DOCKET 50-255 - LICENSE DPR-20 - PALISADES PLANT
TECHNICAL SPECIFICATION CHANGE REQUEST
SPENT FUEL POOL BORON CONCENTRATION

TECHNICAL SPECIFICATION CHANGE REQUEST
SPENT FUEL POOL BORON CONCENTRATION

**ENCLOSURE 1
REQUEST FOR CHANGE TO THE TECHNICAL SPECIFICATIONS
SPENT FUEL POOL BORON CONCENTRATION**

**TECHNICAL SPECIFICATIONS CHANGE REQUEST
SPENT FUEL POOL BORON CONCENTRATION**

Figure 4.3-1 (page 1 of 1)
New Fuel Storage Rack Arrangement

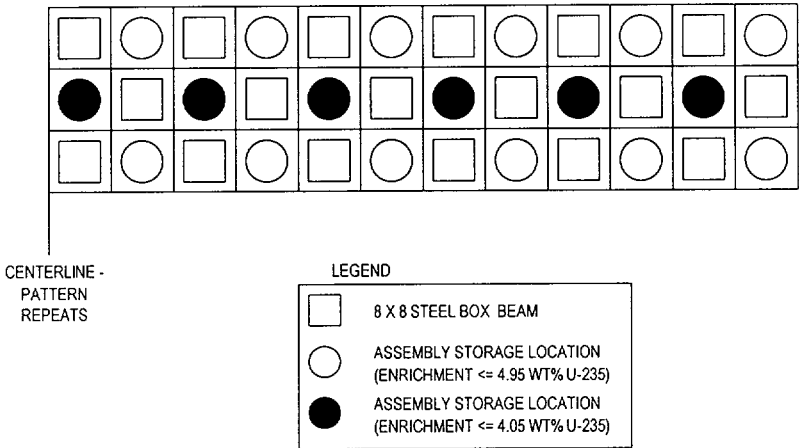
to:
 "Twenty-four unirradiated fuel assemblies having a maximum planar average U-235 enrichment of 4.95 weight percent, and stored in accordance with the pattern shown in Figure 4.3.-1, or

Thirty-six unirradiated fuel assemblies having a maximum planar average U-235 enrichment of 4.05 weight percent, and stored in accordance with the pattern shown in Figure. 4.3.-1."

8. Delete existing Specification 4.3.1.3.c
9. Renumber existing Specification 4.3.1.3d to 4.3.1.3c
10. Add a new figure, Figure 4.3-1; Figure 3 from EA-SFP-99-03.

- a. Twenty four unirradiated fuel assemblies having a maximum planar average U-235 enrichment of 4.95 weight percent, and stored in accordance with the pattern shown in Figure 4.3-1, or

Thirty six unirradiated fuel assemblies having a maximum planar average U-235 enrichment of 4.05 weight percent, and stored in accordance with the pattern shown in Figure 4.3-1;
- b. $K_{\text{eff}} \leq 0.95$ when flooded with either full density or low density (optimum moderation) water including allowances for uncertainties as described in Section 9.11 of the FSAR.

Figure 4.3-1 (page 1 of 1)
New Fuel Storage Rack Arrangement

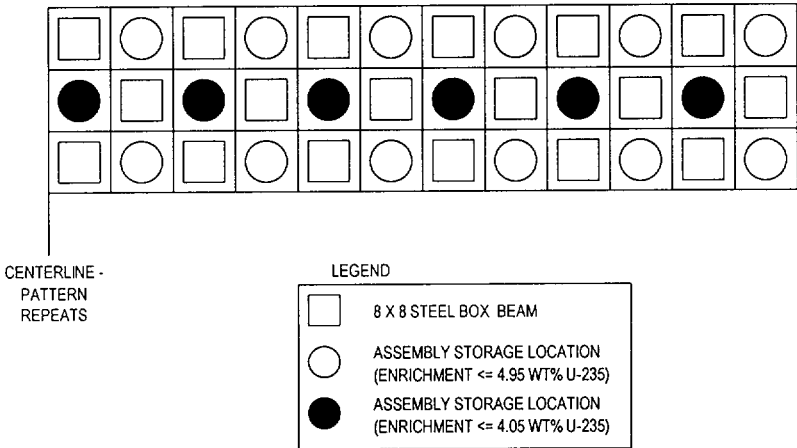
- a. Fuel ~~Twenty four unirradiated fuel assemblies having a maximum average planar U₂₃₅ planar average U-235 enrichment of 4.20~~ 4.95 weight percent, and stored in accordance with the pattern shown in Figure 4.3-1, or

~~Thirty six unirradiated fuel assemblies having a maximum planar average U-235 enrichment of 4.05 weight percent, and stored in accordance with the pattern shown in Figure 4.3-1;~~
- b. $K_{\text{eff}} \leq 0.95$ when flooded with either full density or low density (optimum moderation) water including allowances for uncertainties as described in Section 9.11 of the FSAR.

Figure 3 Palisades New Fuel Storage Rack Loading Patterns.

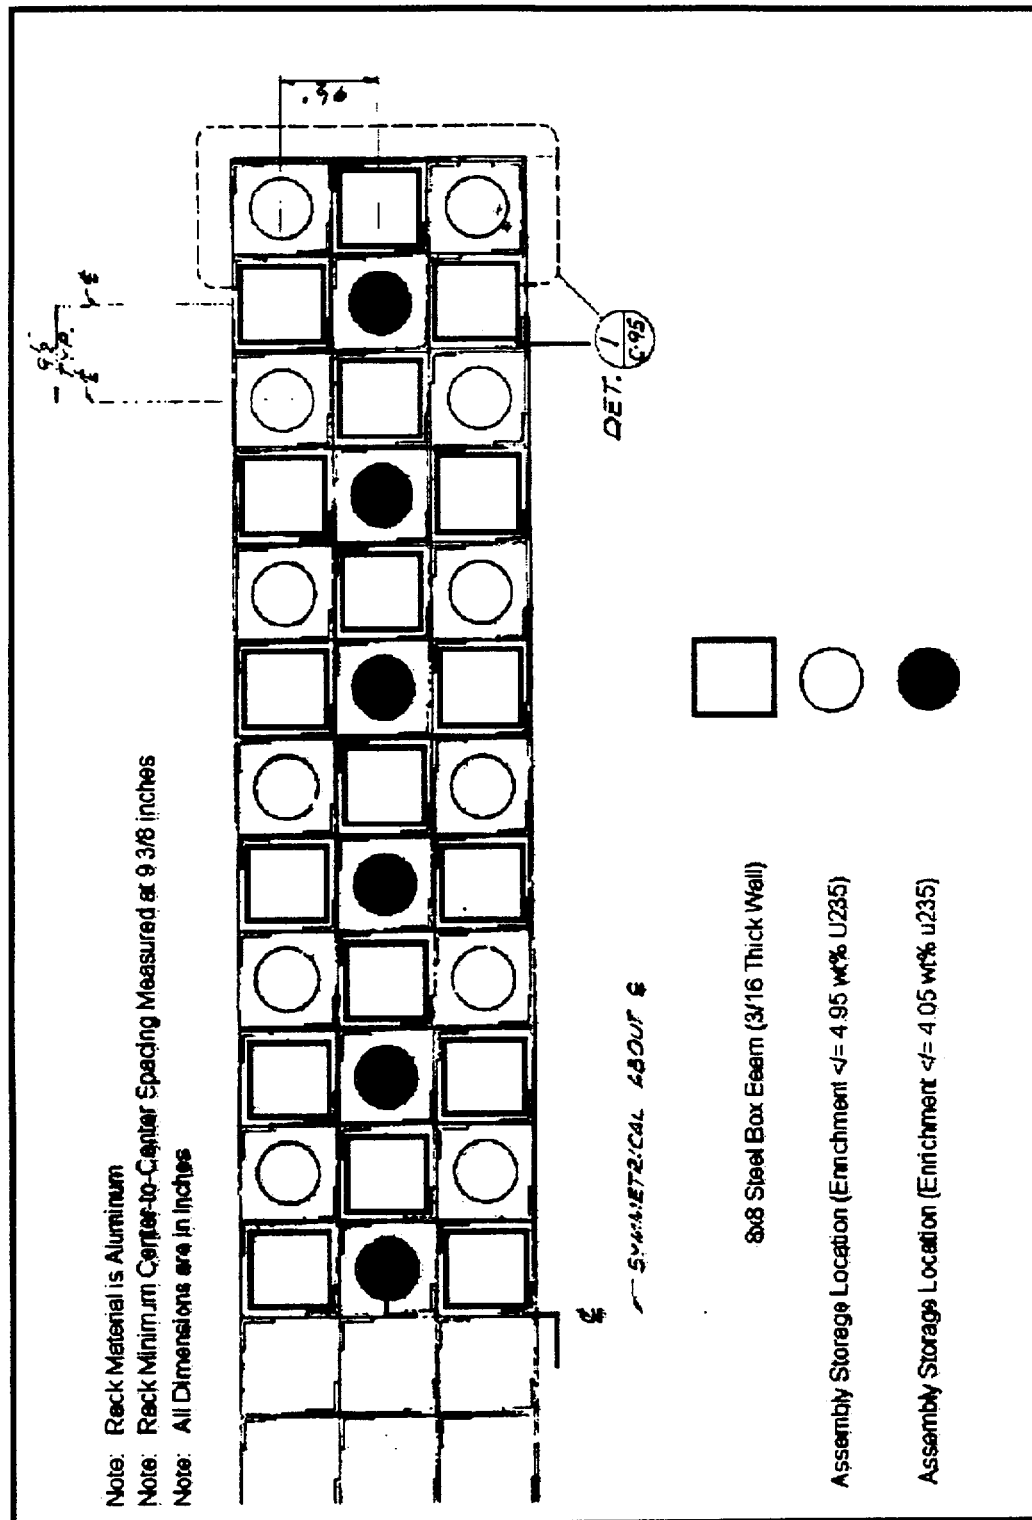
Although there are seventy-two locations in the new fuel storage racks, only 36 are currently available to store fuel. The other half of the rack locations are occupied either by steel box beams or stainless steel core plugs. A specific loading pattern alternating plugs and fuel is assumed. Such a short loading is necessitated by the regulatory requirement to show sub-criticality ($k_{eff} < 0.95$) at optimum moderation conditions. Original design of the rack allowing storage of 72 assemblies assumed normal dry conditions and did not provide spacing or poisoning to account for increased reactivity with added moderation. This analysis considers two loading patterns. First, thirty-six fresh 4.05 wt% assemblies are considered. The assemblies

are positioned in the locations which are not occupied by either core plugs or box beams. A second loading with only twenty-four fresh 4.95 wt% assemblies loaded in the outside two rows of the rack (center row left empty) is also analyzed. Figure 3 shows the two loading patterns considered [2]. Figure 4 shows details the new fuel storage cell design.

or twenty-four 4.95 wt% assemblies [17]. A specific loading pattern is assumed for each enrichment level (i.e. enrichments ≤ 4.05 wt% and enrichments > 4.05 wt% up to 4.95 wt%) as shown in Figure 3. The loading patterns are relatively easy to interpret. Specifically, if any assembly loaded in the new fuel storage rack has a maximum planar average enrichment greater than 4.05 wt%, then no fuel can be loaded into the center row of the rack. The box beams and core plugs remain located in alternating positions regardless of the fuel loading pattern.

Figure 9 Region II Burnup Curves.

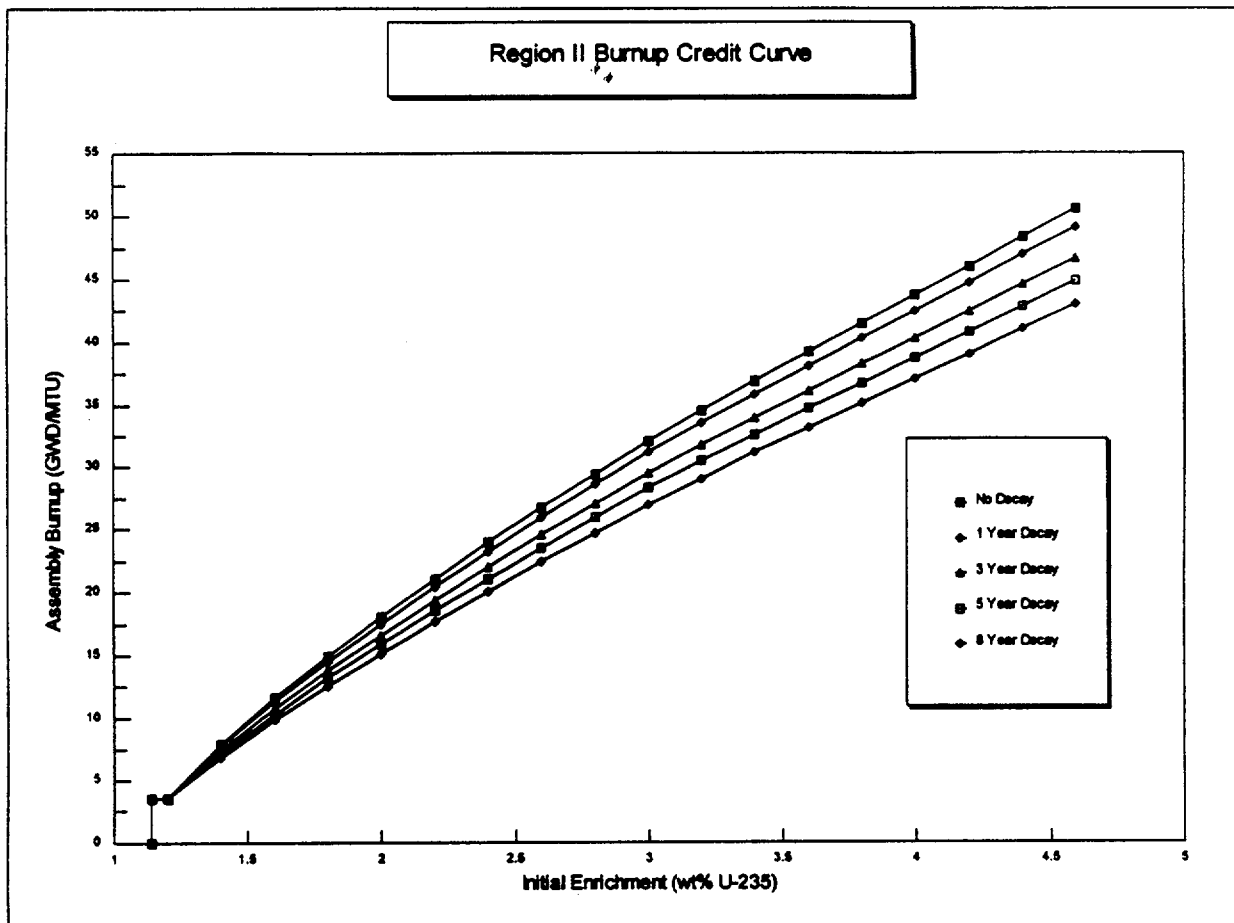
3. Replace Table 3.7.16-1 with Table 4 from EA-SFP-99-03.

The curves presented in Figure 9 are used to determine the eligibility of assemblies for storage in the Region II racks. They are developed to ensure that $k_{95/95-No Boron}$ remains below 1.0 (subcritical). Assemblies are classified by their maximum average planar initial enrichment in wt% ^{235}U . If an assembly has an average

Table 4 provides the data used to create Figure 9. It is acceptable to linearly interpolate between points to determine the required burnup for assemblies with initial enrichments not explicitly stated [33]. In addition, consideration of a 10% uncertainty in assembly burnup records is accounted for in the development of $k_{95/95}$.
850ppm. It is therefore, NOT necessary to reduce stated burnup by a measurement uncertainty up to 10% when evaluating an assembly against the curves.
